**Westmorland Albert Planning Review and Adjustment Committee
Staff Report
Subdivision**

Subject : White Birch Estates Phase 7
Meeting Date: Feb 26, 2015
From : Jeff Boudreau
Manager of Subdivision Approval

Subject: Tentative White Birch Estates Phase 7 Subdivision, Parish of Coverdale, Albert County, DTT map page 359.

Overall Street layout Concept Plan

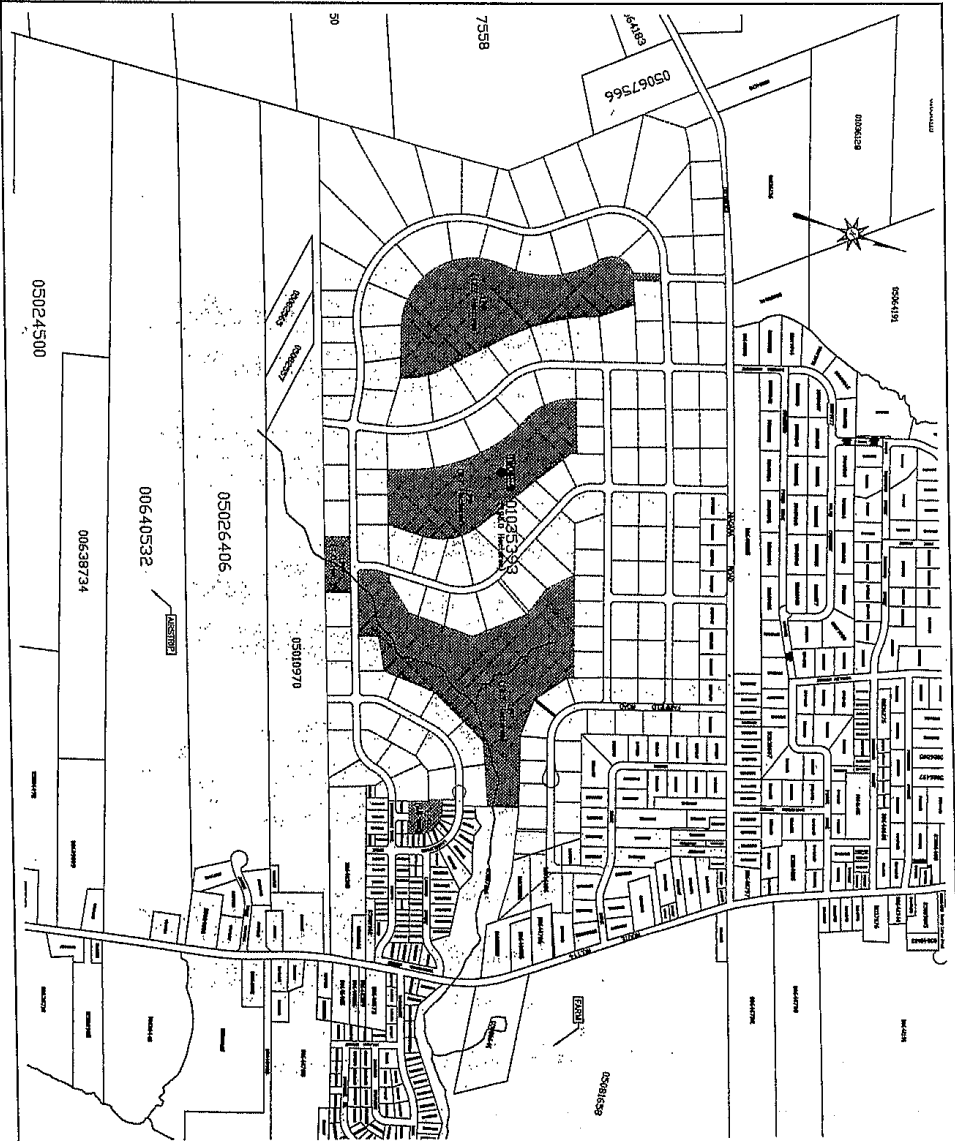
As this is a Phase of an overall layout which was subject to an "E.I.A.", a Certificate of Determination has been issued and contains 9 conditions. The condition which directly relates to the subdivision is #6, requiring a disclosure statement to all potential homeowners about the possible need for water treatment. A copy of the Certificate of Determination is attached to this report.

6. Prospective buyers of the lots on the extension to Fairfield Drive must be informed of the possible need for water quality treatment due to the occurrence of arsenic, fluoride, manganese, pH and turbidity outside of the Canadian Drinking Water Quality Guidelines.

7. A dedicated static water level logger shall be installed in TW06-04 in order to monitor and record static groundwater levels continuously as the development progresses. Should the level logger malfunction, monthly water level readings shall be collected and recorded by hand until such time as the level logger can be repaired or replaced.

8. A subdivision plan and summary of groundwater level monitoring results shall be submitted to the Subdivision Review Coordinator, Sustainable Planning Branch, DELG, for each new phase prior to development.
9. This determination is based on current groundwater and climatological conditions. Should water quantity and/or quality problems arise in the future, further groundwater investigation may be required, as well as a possible modification of the development plan for the remaining lots.
